Amendments to the Drawings

Remarks/Arguments

FIG 1
"PRIOR ART"

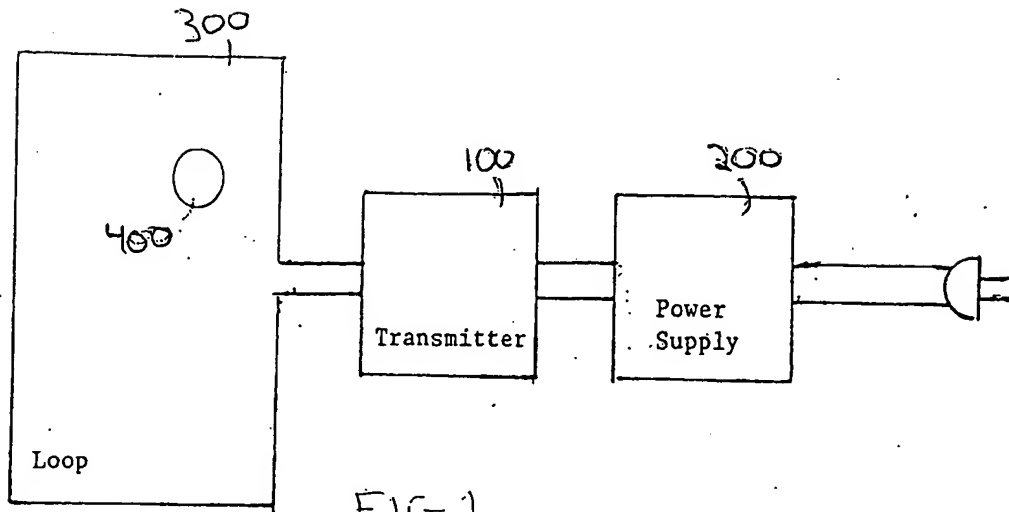
Figures 1 and 6 are objected to under MPEP 608.02(g) as lacking the legend "Prior Art". In response, Figures 1 and 6 are amended to include the legend "Prior Art". Replacement and annotated sheets showing these amendments are attached.

The attached two sheets of drawings includes changes to Figs. 1 and 6. The first sheet, which also includes Fig. 2, replaces the original sheet including Figs. 1 and 2. In Fig. 1, the legend "Prior Art" has been added. The second sheet replaces the original sheet including Fig. 6 and adds the legend "Prior Art" to Fig. 6.
